Laboratory for Electronics, Inc.
Tracerlab Division
1601 Trapelo Road
Waltham 54, Massachusetts

Reference is made to your letter dated December 11, 1963, and the enclosed drawings and description of your Source Models CS-15 and CD-15.

TYPE: CS-15 GAMMA SOURCE CAPSULE

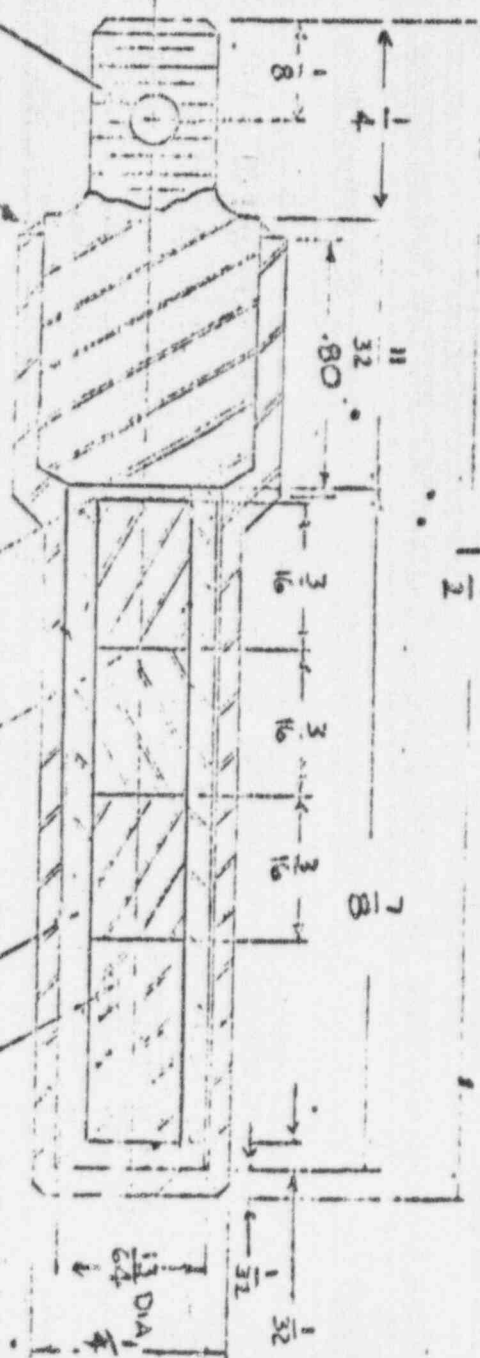
We have evaluated the design of the sources and find them acceptable for licensing purposes.
